Endure Sta. 364+36.00 Customer Sta: 29823+08.0
Wall Thickness: 0.745 in
Min CSD: 34.104 in Max CSD: 41.624 in
Deformation - Dent with associated ovality
Orientation: 11:58

809-509B2 Survey Station: 29741+63.6

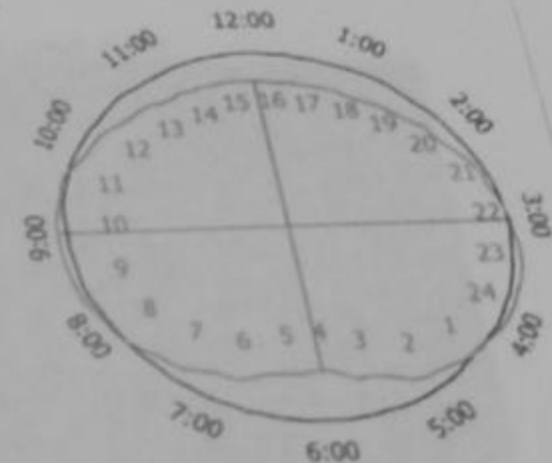
Estimated dent size after excavation: 1.194 in
Affects girth weld
Field Reported

Possible Debris

This "trimmed to fit" bend appears to be under stress. Further analysis will be needed in this area to verify.

Possible stress located at this bend. A measurement for stress on this bend will not be very accurate due to the debris induced vibration seen on the upstream side of this factory bend.
